REMEDIATION SYSTEM EVALUATION

FORMER OCCIDENTAL FACILITY TACOMA, WASHINGTON

Report of the Remediation System Evaluation,
Site Visit Conducted at the Former Occidental Facility, Tacoma, Washington
July 8, 2003

EPA 542-F-04-026
August 2004
www.epa.gov/tio
clu-in.org/optimization

FIGURE 1-6. EXTENT OF CONTAMINATION AT 100 FEET BELOW GROUND SURFACE - AUGUST 2002

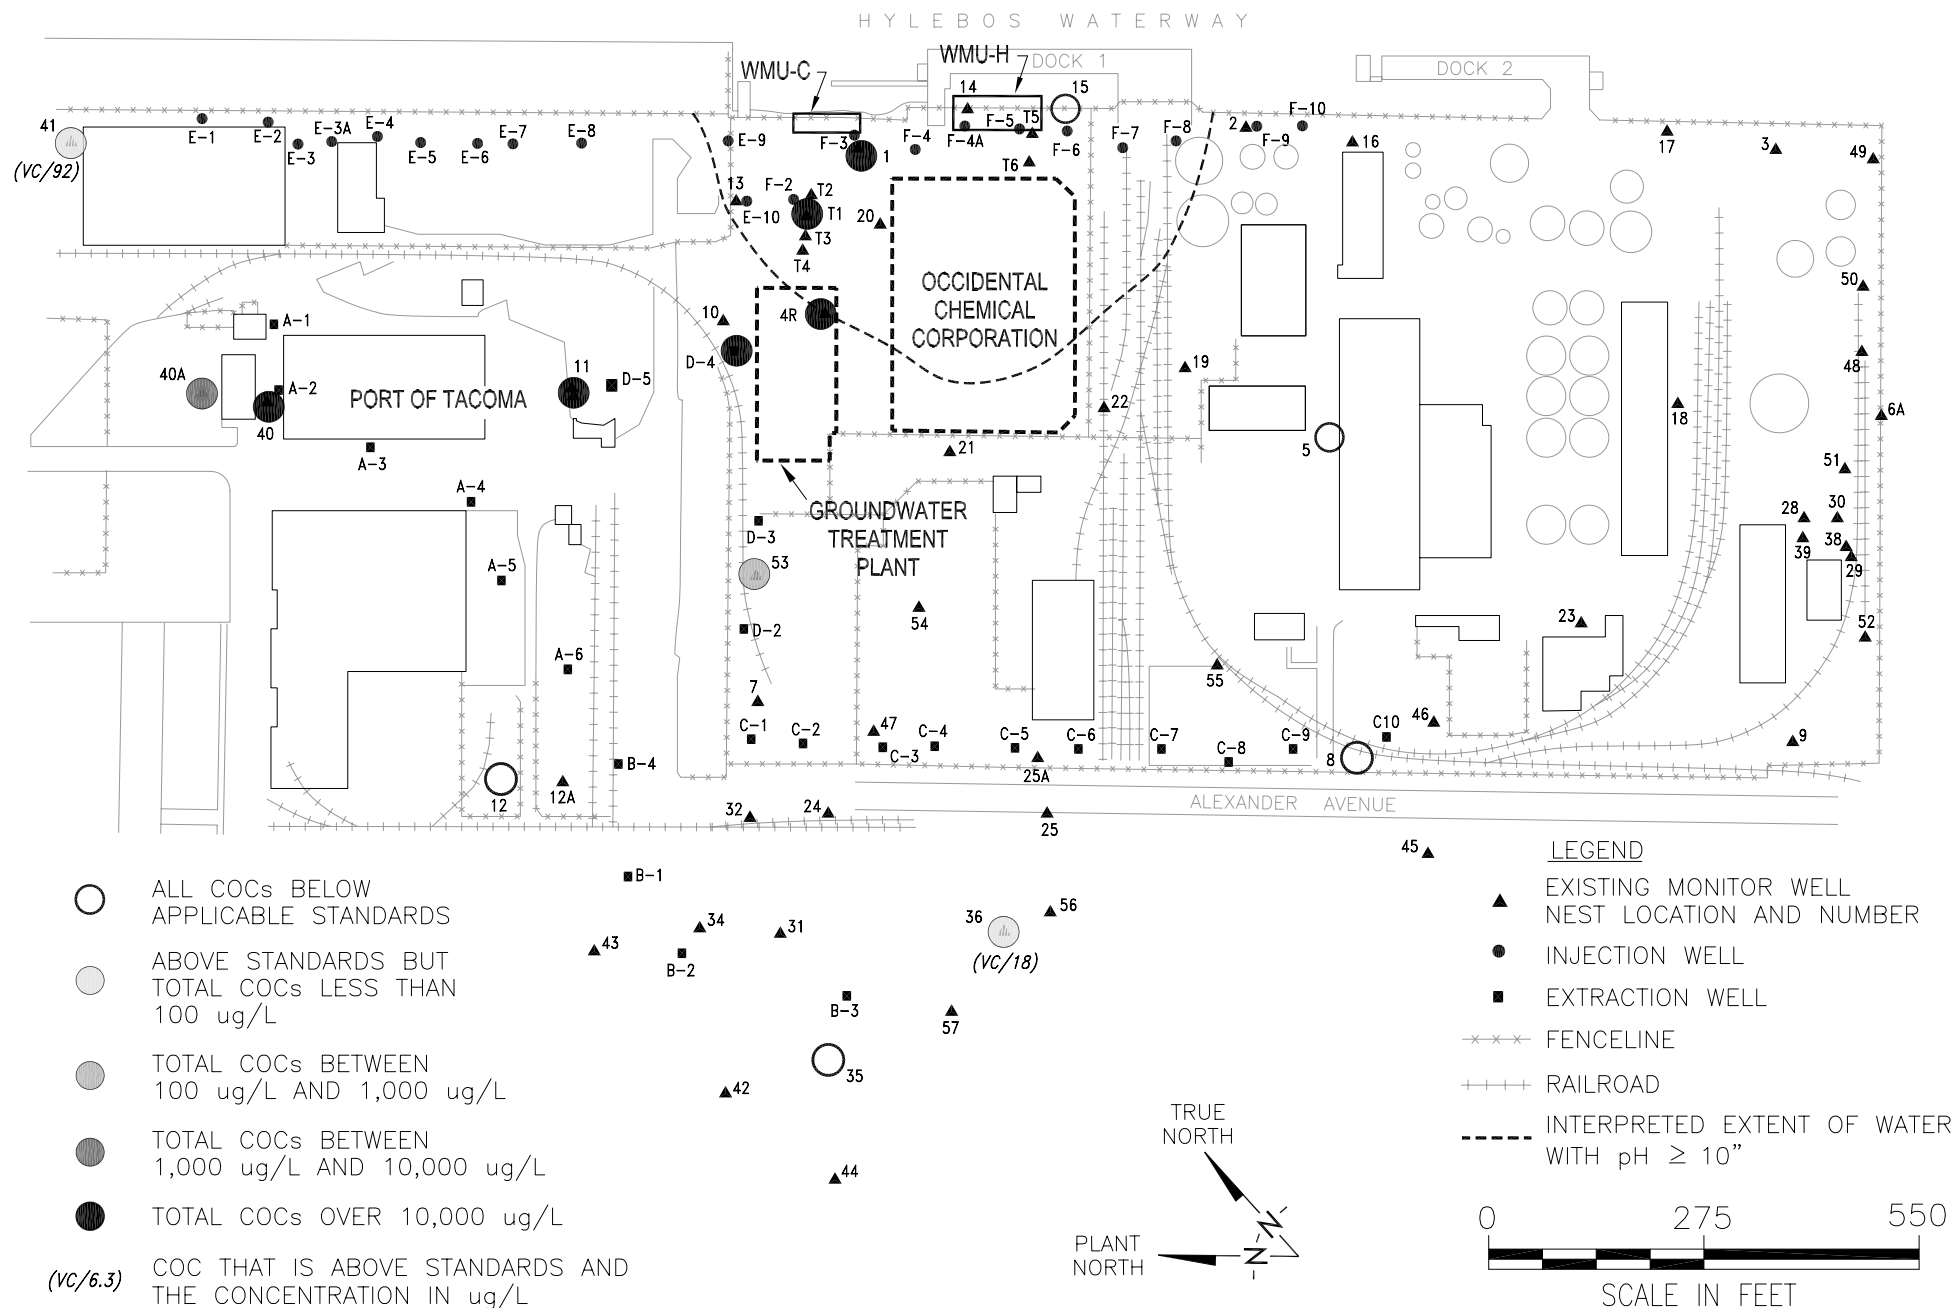
Capture at the 100-foot depth interval is inconclusive due to a lack of data, and a thorough capture evaluation at this depth is also complicated by the lack of plume delineation. In particular, the concentrations at monitoring wells 41-138, 40A-100, and 40-100 all have VOCs well above relevant cleanup standards, and there are no monitoring wells or extraction wells downgradient of these locations to provide delineation. The substantial decrease in VOC concentrations in 41-138 could be interpreted as an indication of capture, but the decrease started well before the addition of A-2A. Therefore, the decrease is likely due to dilution from the injection of clean water at E-1 and the movement of contaminated water further from the site. The increases in VOC concentrations at 40A-100 and 40-100 might indicate that these wells are within the capture zones of nearby extraction wells and that contaminated ground water is passing through these monitoring wells on route to extraction at A-2A. It could also potentially represent uncaptured contamination. Moreover, substantial contamination may exist beyond 40A-100 and 40-100 given that these two wells have substantial concentrations (38,000 ug/L of total contaminants of concern at 40-100 and 9,800 ug/L of total contaminants of concern at 40A-100 in August 2002) and no monitoring points are available to the north.

- Additional monitoring wells are needed to delineate the VOC plume to the north approximately 100 feet below ground surface. The RSE team estimates that approximately four wells to this depth will be needed.

FIGURE 1-7. EXAMPLE POTENTIOMETRIC SURFACE MAP FOR THE 25-FOOT INTERVAL (JANUARY 2002) SUBMITTED AS PART OF AN ANNUAL PERFORMANCE EVALUATION REPORT.

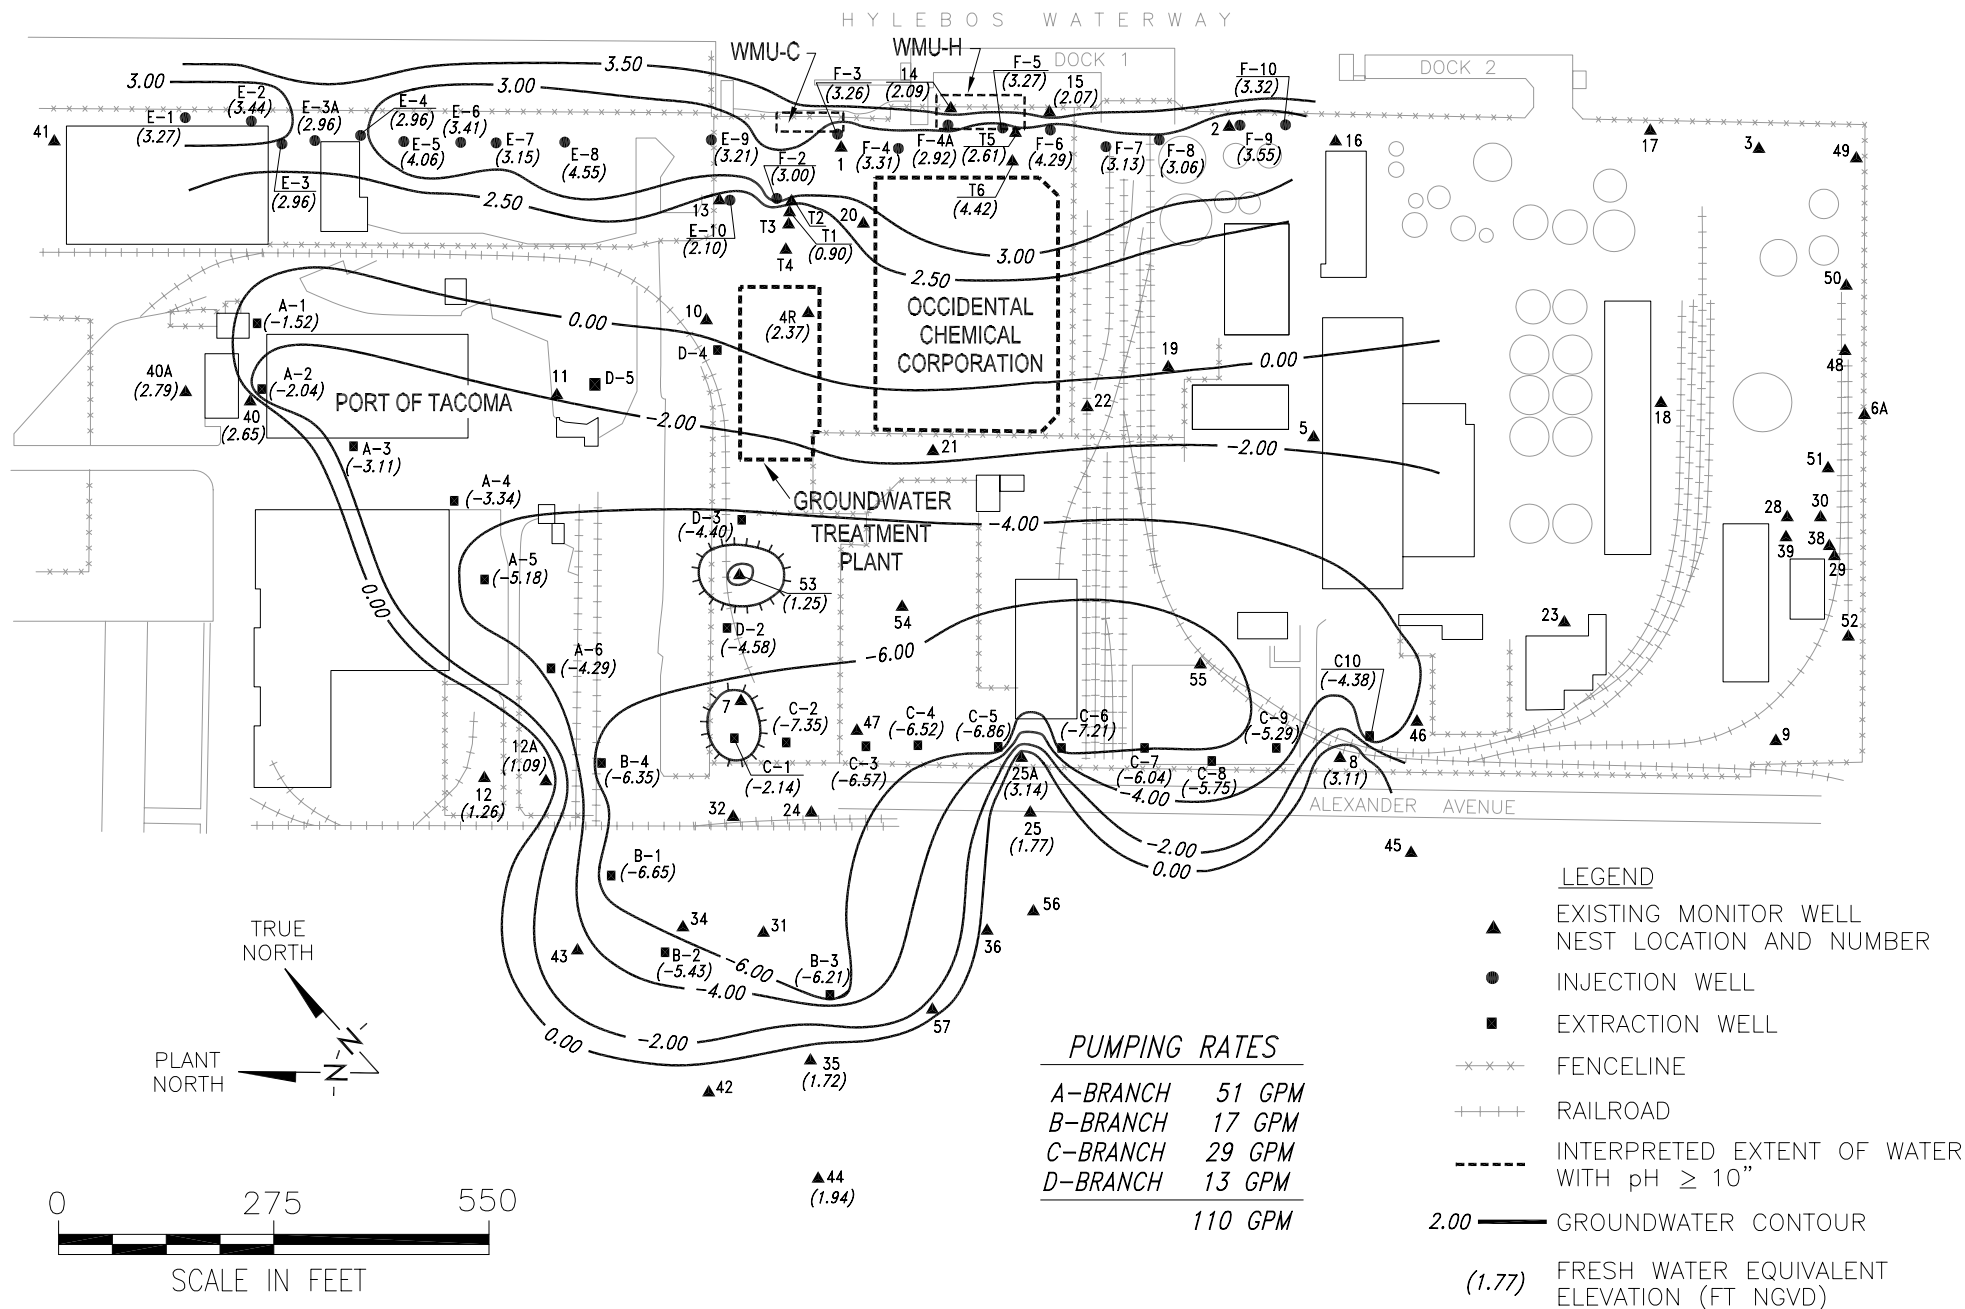
Potentiometric surface maps are generated and reported for each of the three depth intervals (25, 50, and 100 feet bgs) on a quarterly basis. For the 25 and 50-foot intervals, the maps are generated using water levels from monitoring wells and operating injection and extraction wells. However, the water levels from operating injection and extraction wells are not likely indicative of aquifer conditions and using these maps to draw conclusions about plume capture is unreliable. Figure 4-1 provides an example of a potentiometric surface map generated from the January 2002 water level data. The RSE team notes the following inconsistencies from this particular potentiometric surface map and that similar inconsistencies are present in other submitted potentiometric surface maps.

Using data from monitoring wells (and not injection or extraction wells) would provide a different picture of ground water flow across the site. The following examples are provided:

- Plume capture should be enhanced by abandoning the current injection system and increasing extraction throughout the site, where practicable.
- Evaluation of plume capture through the use of potentiometric surface maps developed from site-wide water level measurements and tidal corrections should be discontinued and replaced with more cost-effective and reliable approaches.
